Technical Clarifications – Further Information Request

Fishguard
Replacement
Linkspan

V01
22nd September
2025

Figure 1-1 Vibrocore and borehole locations analysed within the InSitu and FUGRO site investigation surveys

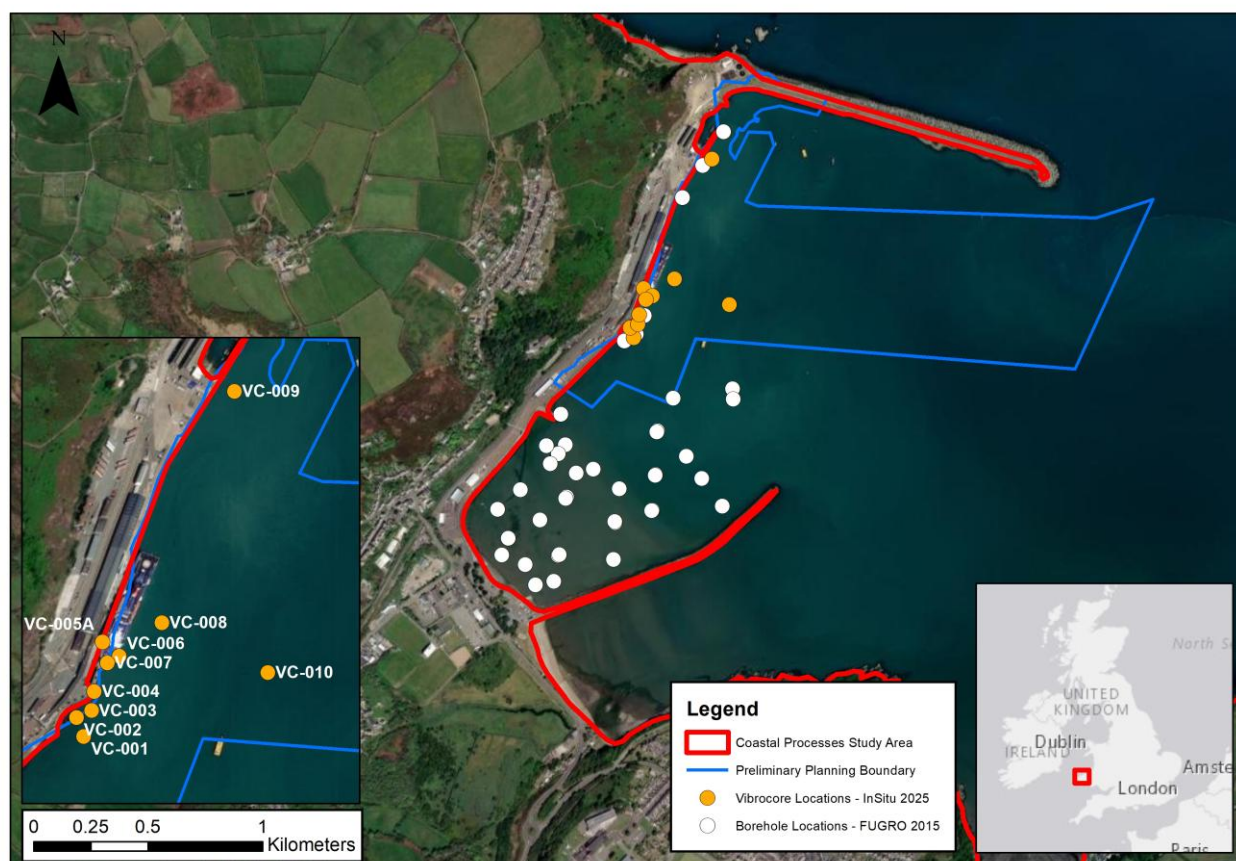
1.2 Item 37 – Amended Figure 10-14 ES Vol 1 Main Text, Part 1

Figure 1-2 Overview of all non-impulsive sources

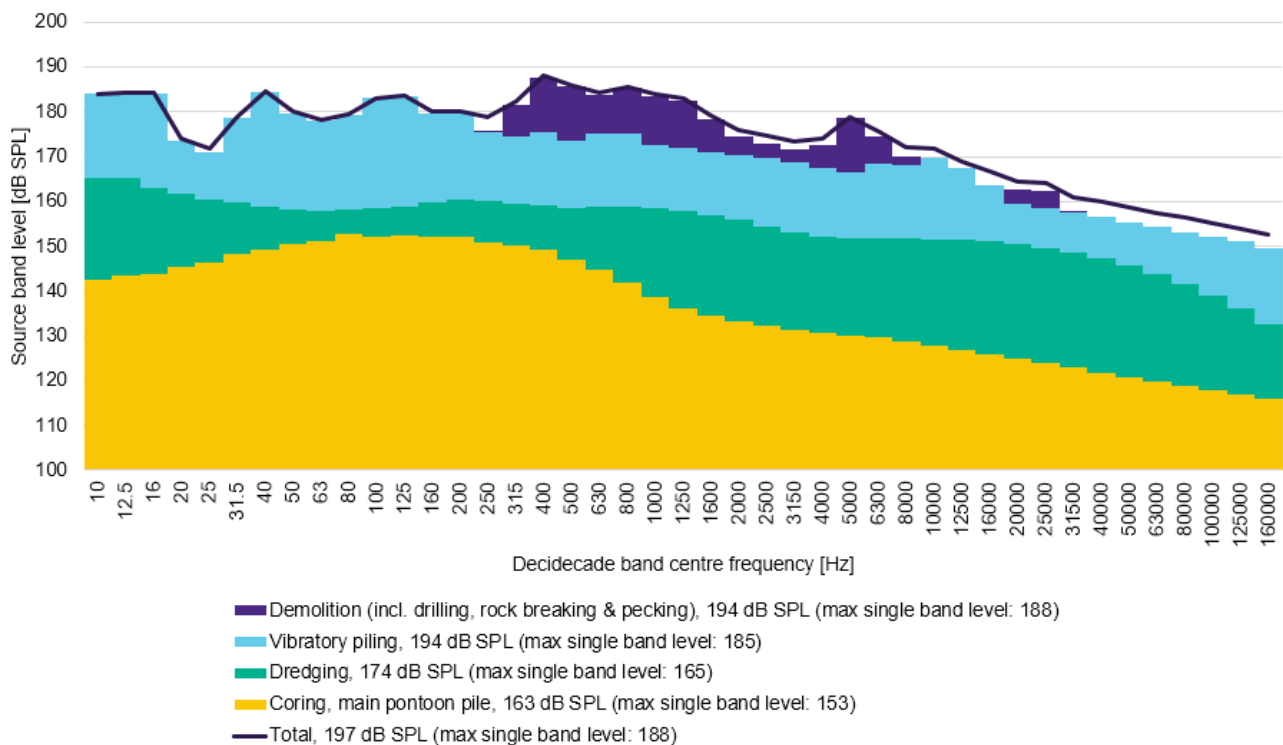
To support the information above we provide an overview of auditory effect ranges for all non-impulsive activities demonstrating that even if there was overlap (not proposed) there would be no material effect on the conclusions of the assessment:

Assuming all the above are active together: the total broadband source level would be 197 dB SPL. Figure 1-2 Overview of all non-impulsive sources, 3 dB above vibro piling (194 dB) or demolition (194 dB) alone. Note that while the broadband level has increased by 3 dB, the maximal single band level is unlikely to increase and remains 188 dB SPL (Figure 1 1, compare “Demolition” and “Total”).

After applying the LF and VHF weightings we see that the total level, assuming all sources are active at the same time and in the same location, is increased by 1 dB for the LF group and by 2 dB for the VHF group.

- LF group: Increase by a factor of 1.25 (2 dB) to c. 730 m (from 580 m)
- VHF group: increase by a factor of 1.6 (2 dB) to c. 650 m (from 410 m)

AUD INJ ranges for both to be <20 m.

Thus, even though NRW's comments are valid, the effect on the assessment is in our opinion not significant as under very conservative assumptions (unplanned concurrency in the noisiest activities) the expected increase in TTS ranges is small. We will however seek to include such considerations more clearly in future assessments if activities are likely to overlap as NRW are correct in pointing out the potential for overlapping activities to increase the risk ranges for auditory impacts.
